Project:	NEWTECH Skill Center Phase 2 Modernization Spokane Public Schools 4141 North Regal Street Spokane, WA 99207	Date:	October 20, 2015
BWA No:	14-370	Addendum No:	Three

This Addendum consists of a total of 5 pages and 10 drawings.

DETAILS SYMBOL
RE: A2.13 FLOOR PLAN - NORTH

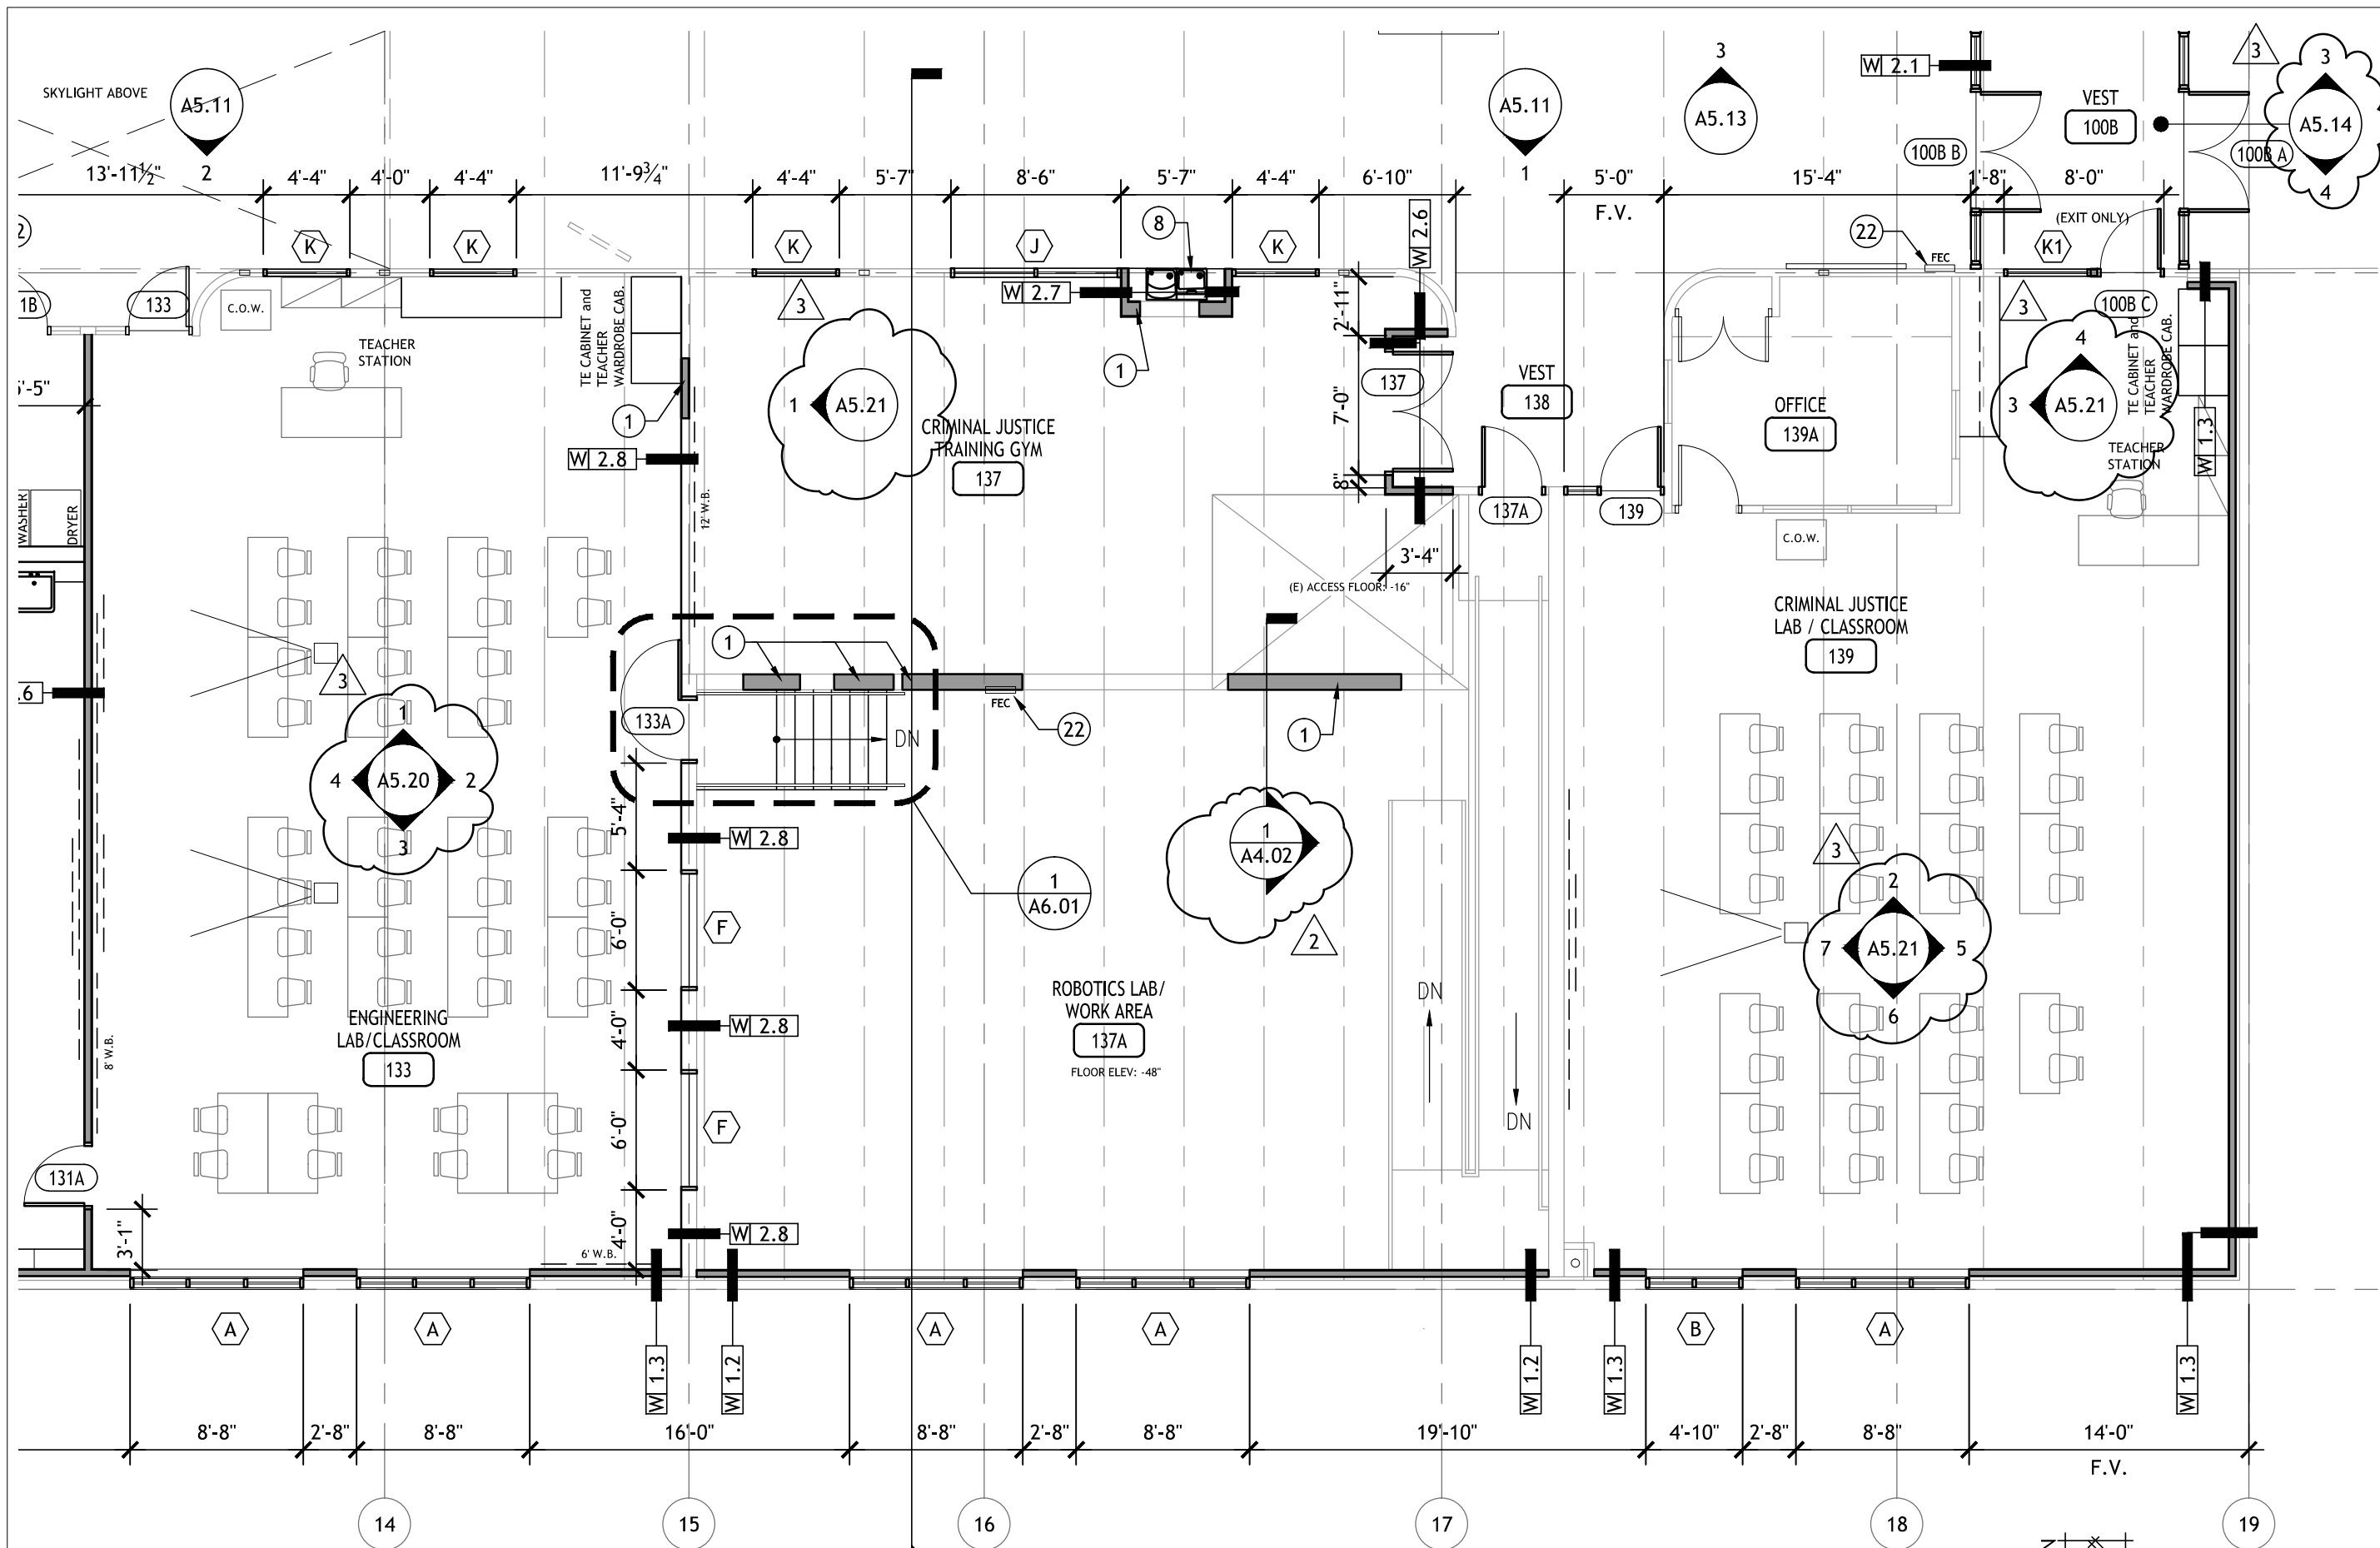
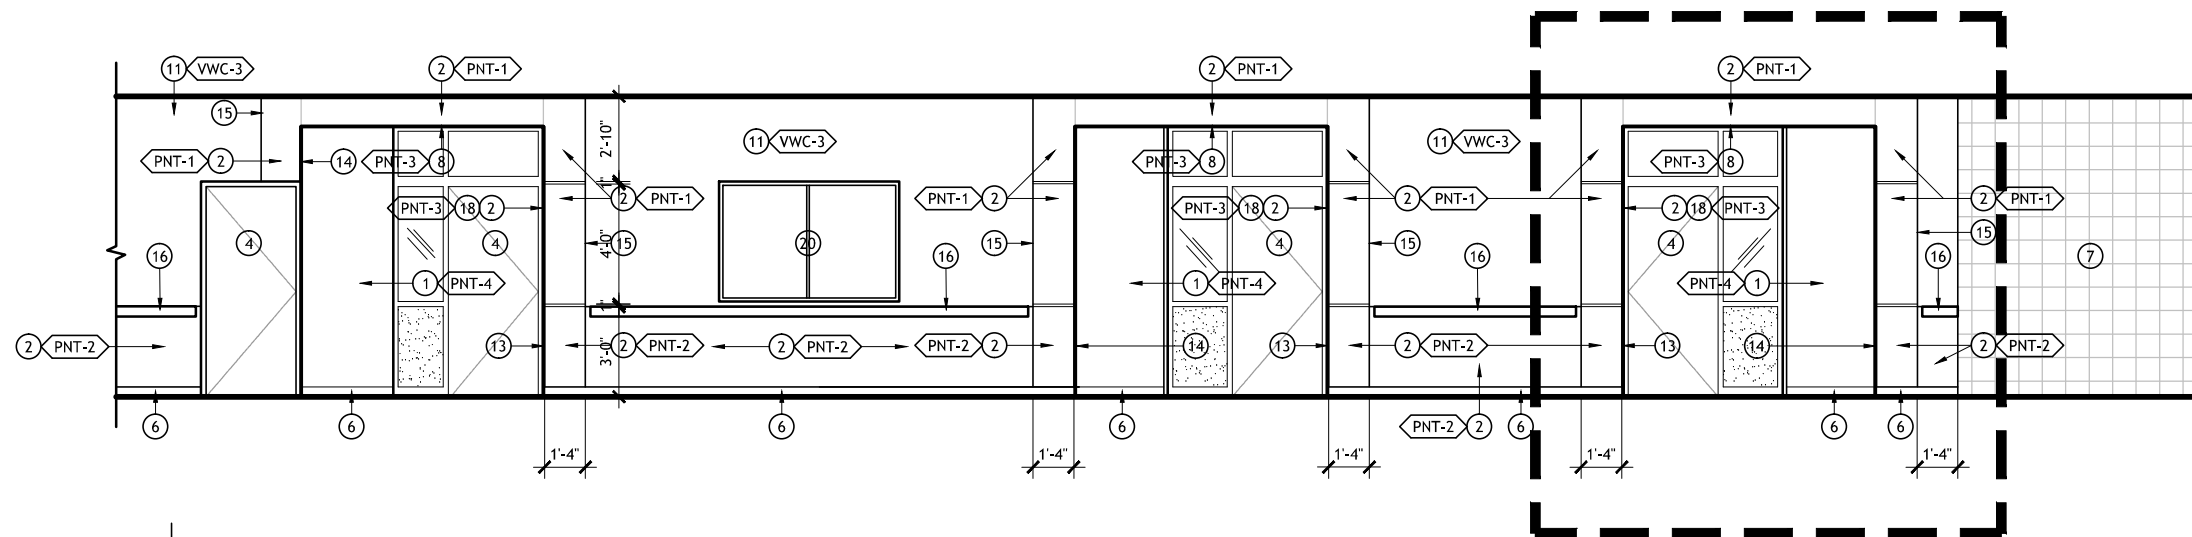
1. Drawing A2.13 – FLOOR PLAN - NORTH: Add interior elevation callouts in Rooms 123, 127, 131, 131B, 139 and Vestibule 100B. See attached drawings A3.06 and A3.07.

3 ENLARGED HALL 100 (ALTERNATE #3)

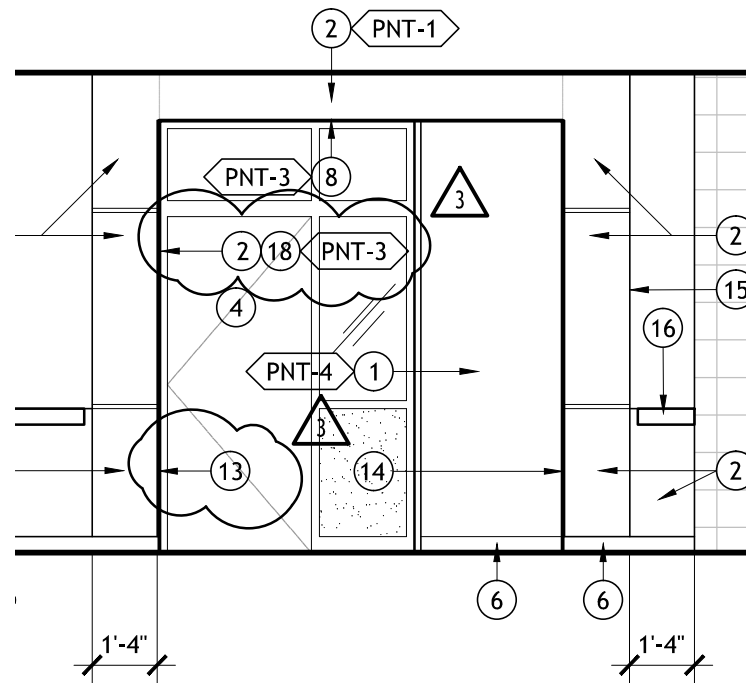
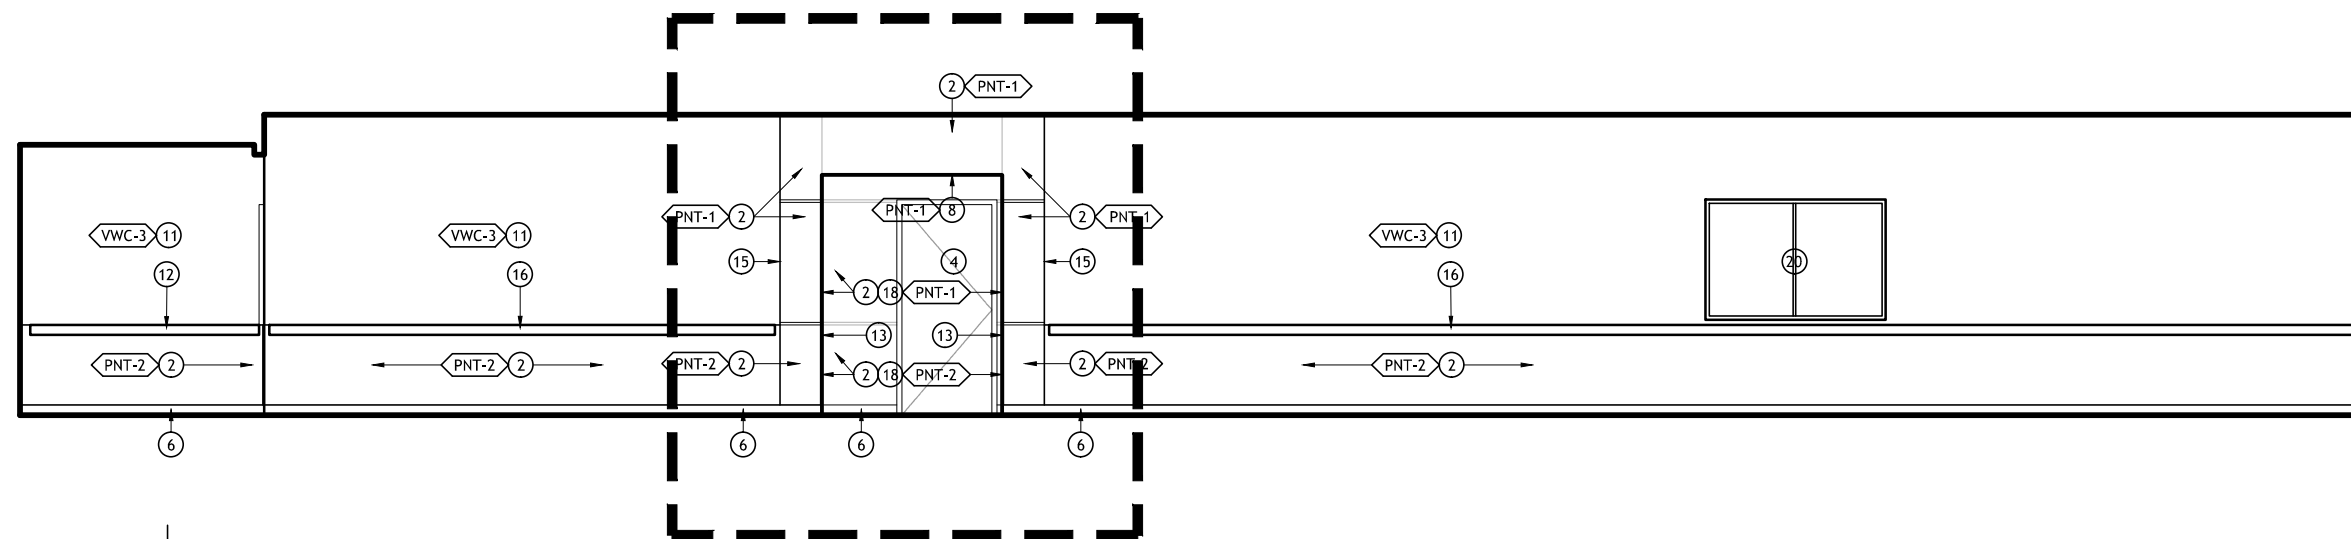
1. Drawing A5.11 / INTERIOR ELEVATIONS:
 - a. Elevations, Detail 3 – Add Notes 2, 13, & 18. See attached drawing A3.08.
2. Drawing A5.12 / INTERIOR ELEVATIONS:

ENLARGED HALL 100 DOOR ALCOVE, TYP. (ALTERNATE #3)

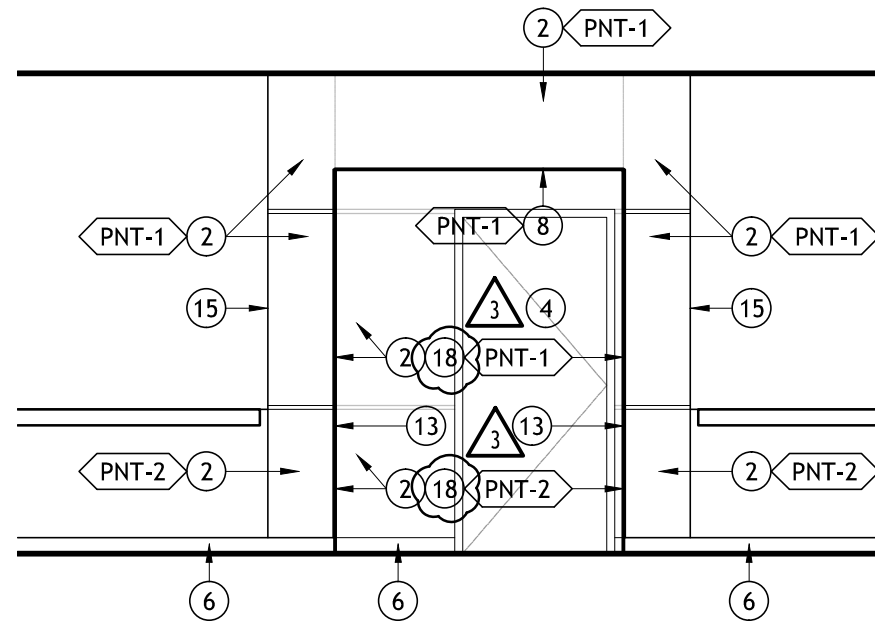
- a. Elevations, Details 3, 4, & 5 – Add Note 18. See attached drawing A3.09 for typical west corridor door alcove.
3. Drawing A5.14 / INTERIOR ELEVATIONS:
